State of Alaska
Department of Fish and Game
Sportfish Division

Nomination Form
Anadromous Waters Catalog

Anadromous Waters Catalog Number of Water Body 114-25-10100 and 114-25-10120

Nomination # <u>24-808</u>	<u>Adrian Keim</u> Fisheries Scientist Date <u>9-11-2024</u>
Revision Year: <u>2025</u>	<u>Ron Benhart</u> Habitat Operations Manager Date <u>9/10/2024</u>
Revision to: <input checked="" type="checkbox"/> Atlas <input checked="" type="checkbox"/> Catalog	<u>Joseph Huf</u> AWC Project Biologist Date <u>15 Aug 2024</u>
Revision Code: <u>C-9, B-1, B-2</u>	<u>P.C.</u> GIS Analyst Date <u>9/12/2024</u>

Figure 7.- A map of 114-25-10120 showing observation locations and route corrections.

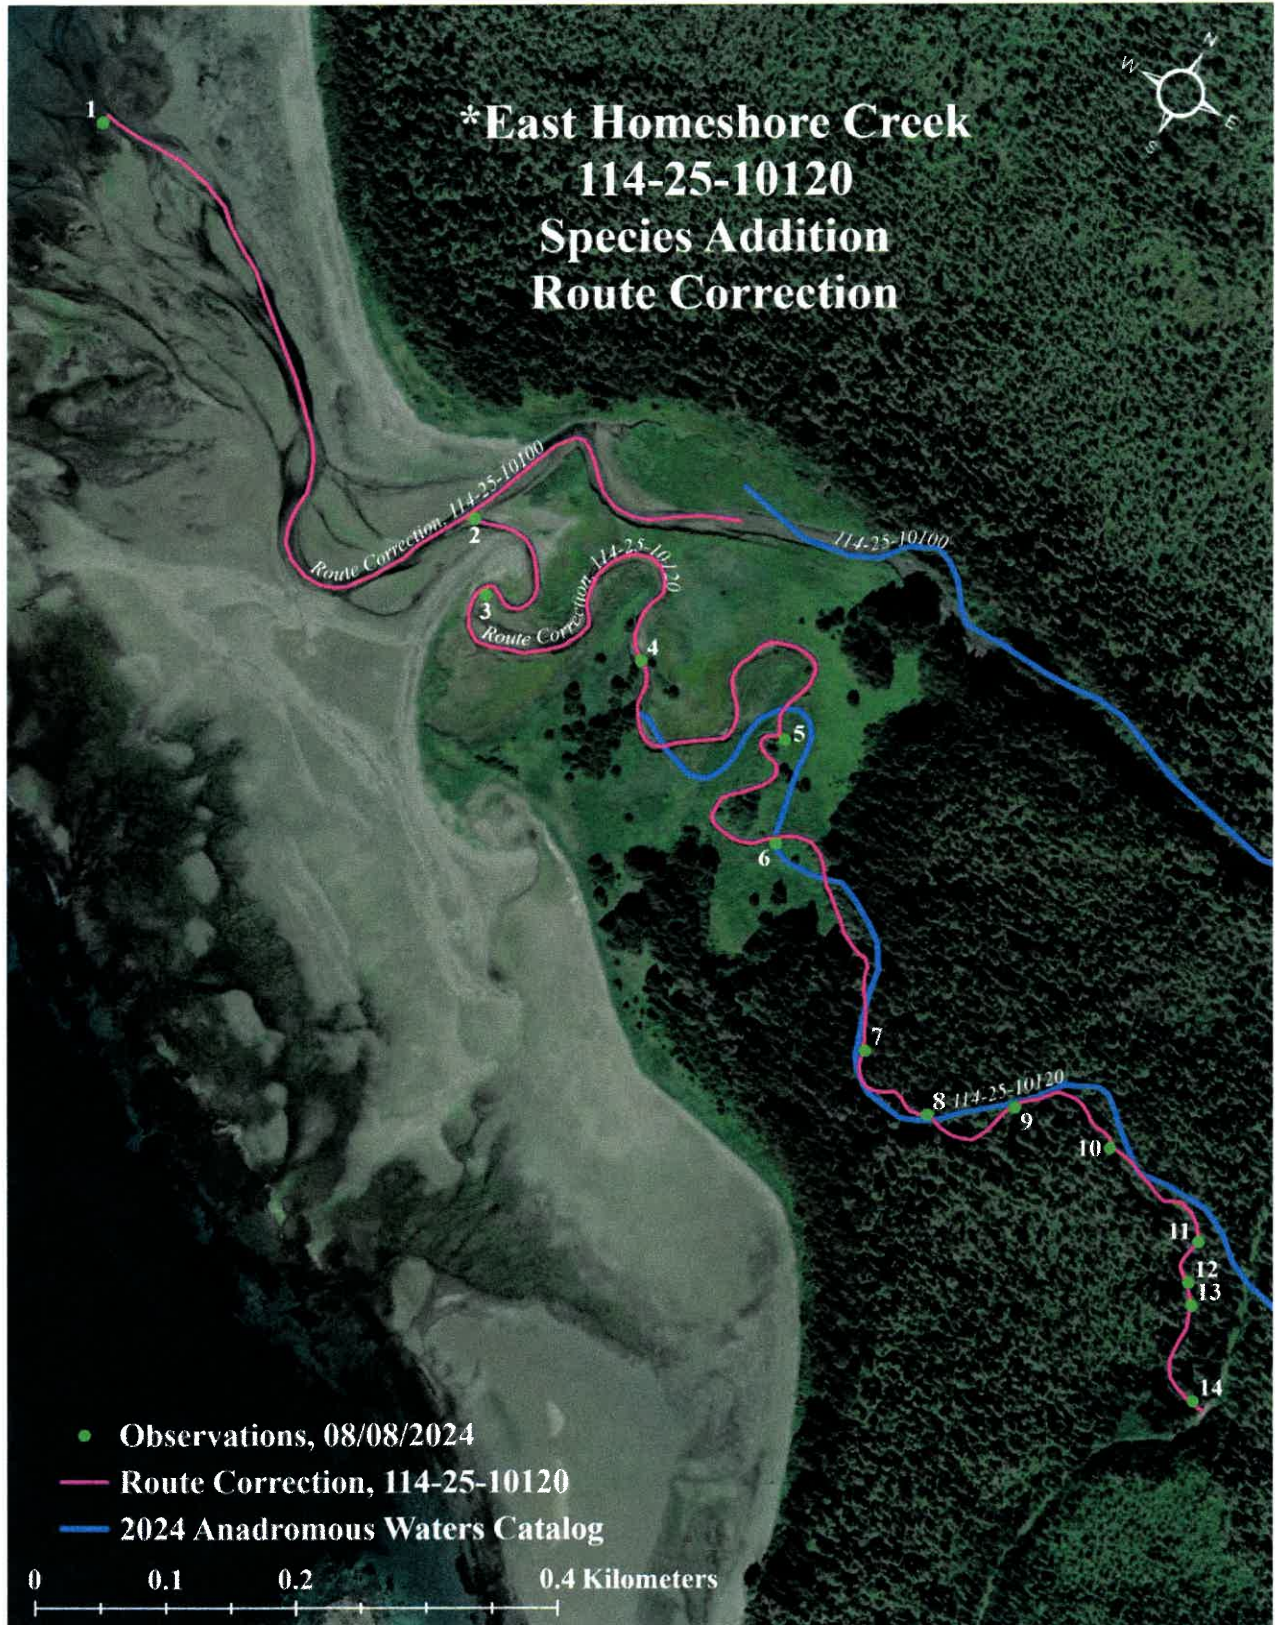
This one was kicked back during the internal review to request additional information about the barrier. Mark lists some pretty steep measurements but the picture doesn't exactly illustrate that at first glance and then he used the word "probable" barrier to adult's in his description.

I see in your 2024 data you also noted this feature, would you concur that this is a likely barrier and the upper extent of the stream should be shortened?

I am not sure if I would definitely call it a barrier. We only set one trap upstream since it was already cataloged and we generally hit those as a last priority when surveying an area. The FS calls it class 1 above so I would probably keep the upper extent and we can do a more extensive look if we get back there. Thoughts?

Map #1

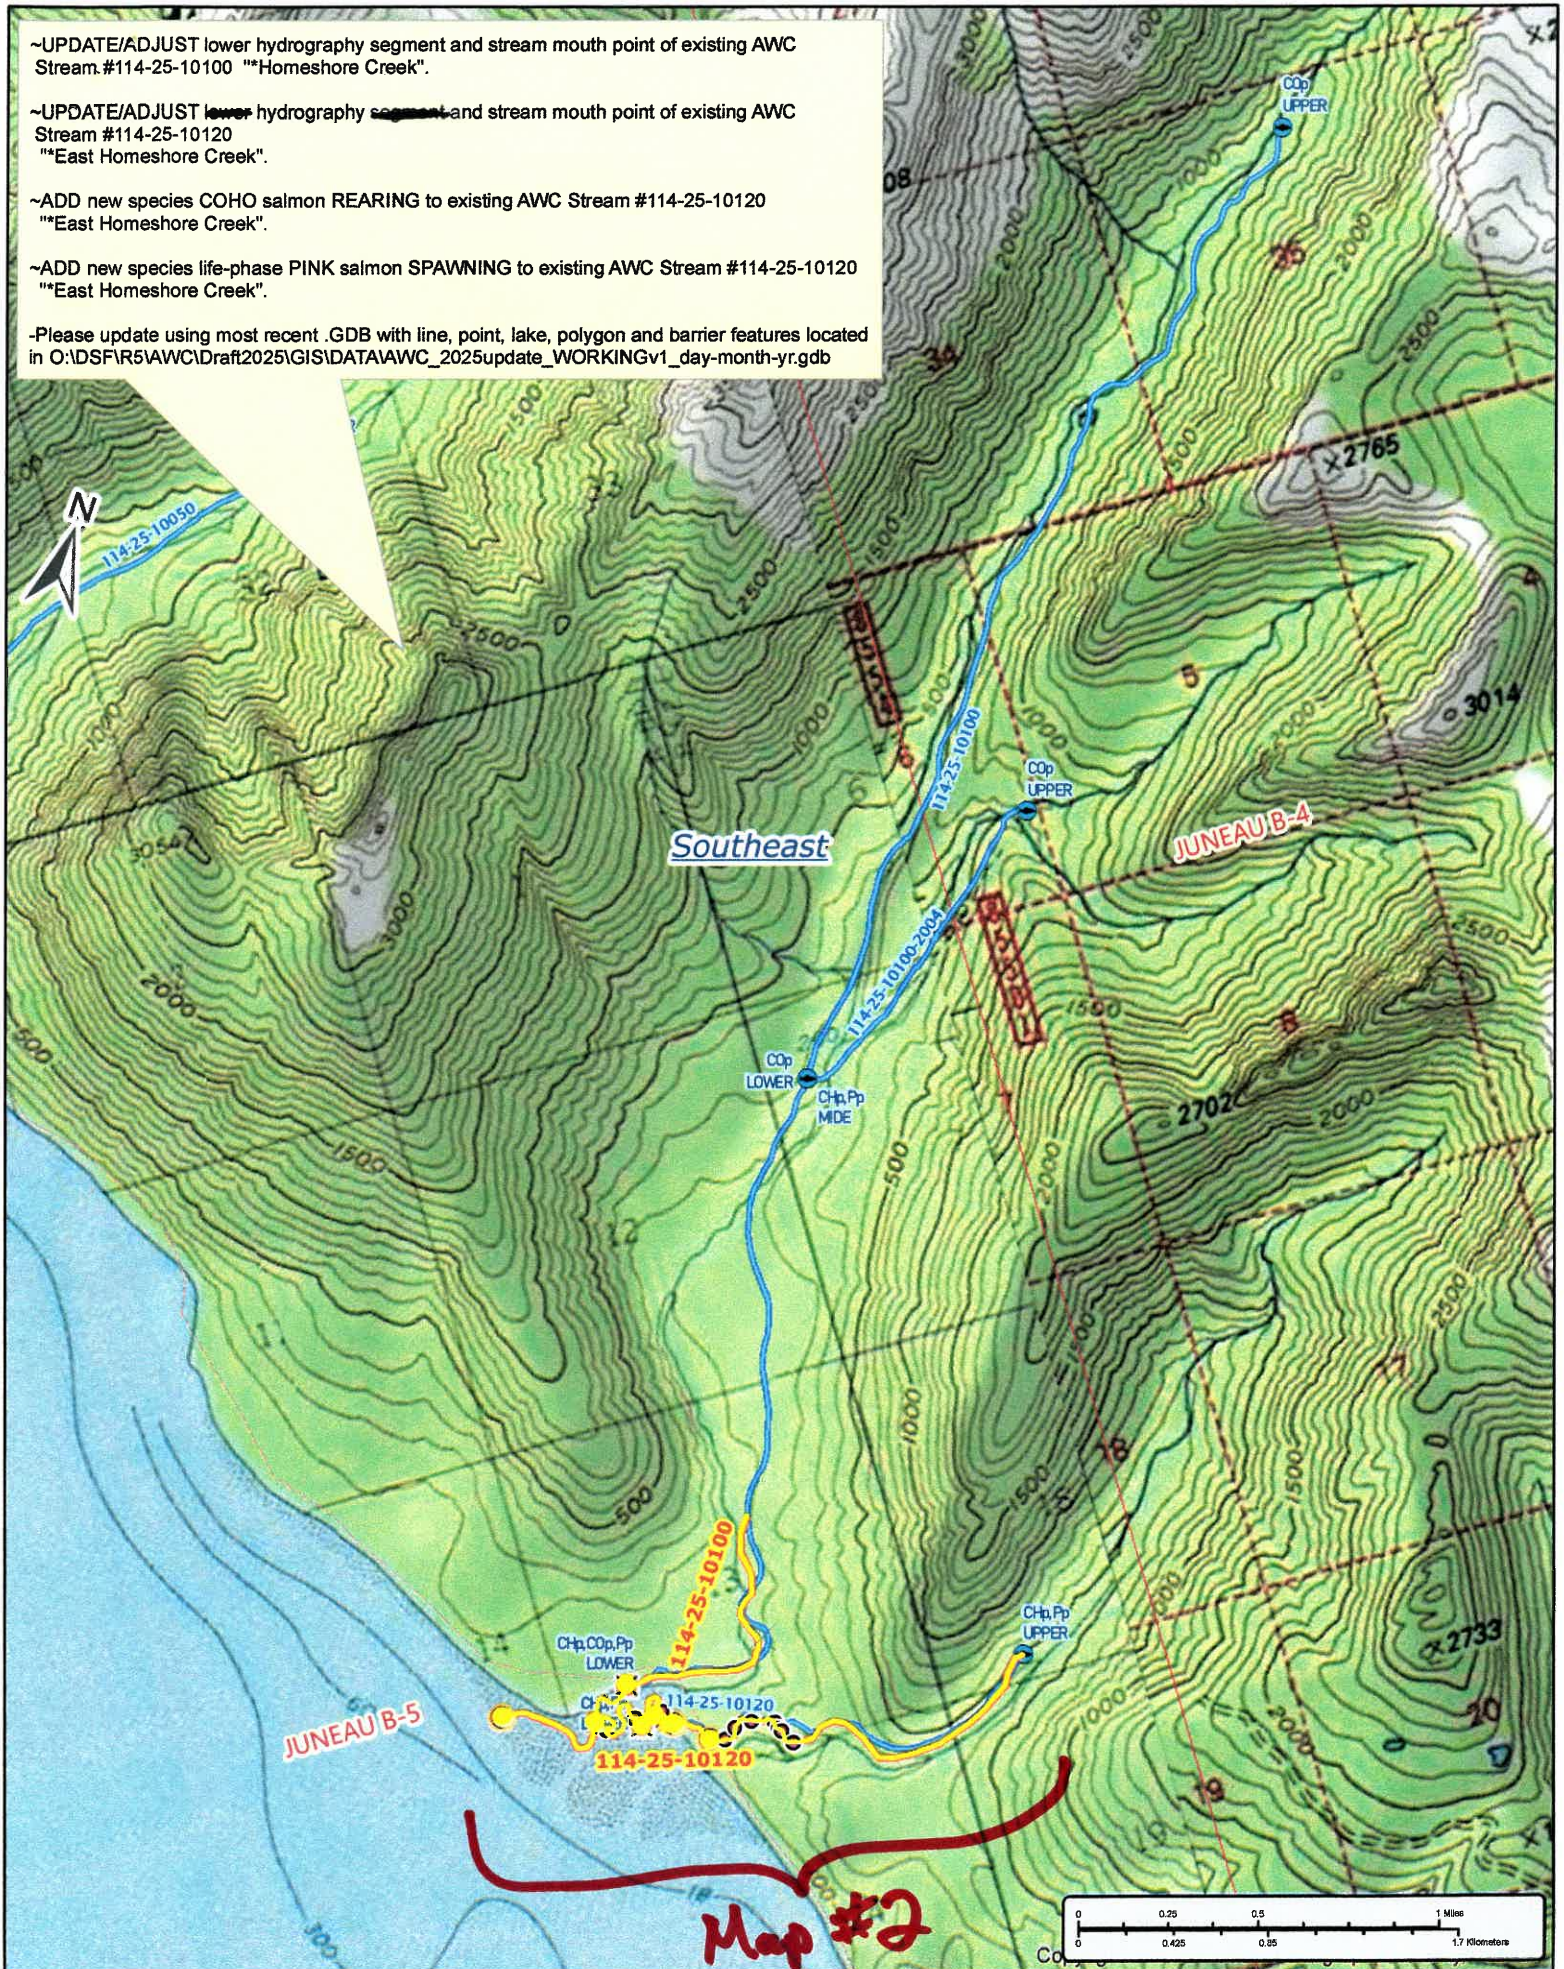
~UPDATE/ADJUST lower hydrography segment and stream mouth point of existing AWC Stream #114-25-10100 "Homeshore Creek".

~UPDATE/ADJUST ~~lower~~ hydrography ~~segment~~ and stream mouth point of existing AWC Stream #114-25-10120 "East Homeshore Creek".

~ADD new species COHO salmon REARING to existing AWC Stream #114-25-10120 "East Homeshore Creek".

~ADD new species life-phase PINK salmon SPAWNING to existing AWC Stream #114-25-10120 "East Homeshore Creek".

~Please update using most recent .GDB with line, point, lake, polygon and barrier features located in O:\DSF\R5\AWC\Draft2025\GIS\DATA\AWC\_2025update\_WORKINGv1\_day-month-yr.gdb

Public Review Corrections:

~ADD new species Dolly Varden PRESENT to existing AWC Stream #114-25-10100 ""Homeshore Creek".

~ADD new species COHO salmon REARING and Dolly Varden PRESENT to existing AWC Stream #114-25-10120 ""East Homeshore Creek".

In nomination #24-808 (\*East Homeshore Ck, 114-25-10120), I noted the presence of several large Dolly Varden at waypoints 5 and 6. The portion of my notes with reference to DV is highlighted, but anadromous DV are left out of the "change" lines in the processed nomination.
